MIL-C-39012C
AMENDMENT 5

FIGURE 6. Safety wire hole pullout procedure.

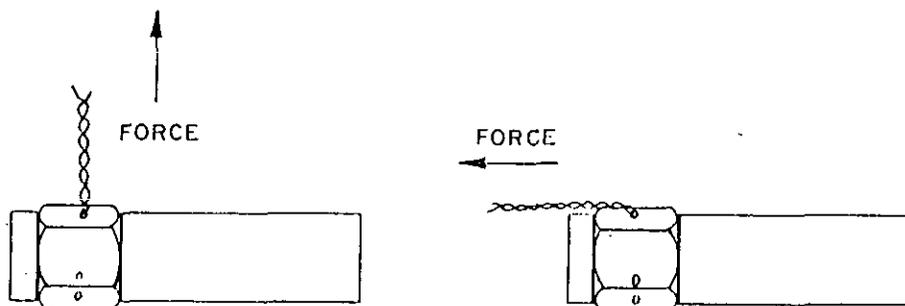
Add 4.6.25 as follows:

"4.6.25 Safety wire hole pullout (see 3.32). A single strand of safety wire shall be looped through the safety wire hole and secured to itself. Forces of 15 pounds (67 newtons) minimum shall be applied to the safety wire pulling away from the connector. One pull shall be parallel to the connector axis and one pull perpendicular to the connector axis (see figure 6). The safety wire shall be corrosion resistant steel .020 inch diameter (24 gauge) or .015 inch diameter, (27 gauge) in accordance with MS20995. This test is to be conducted under static conditions. All holes are to be tested individually."

Add figure 6 as follows:
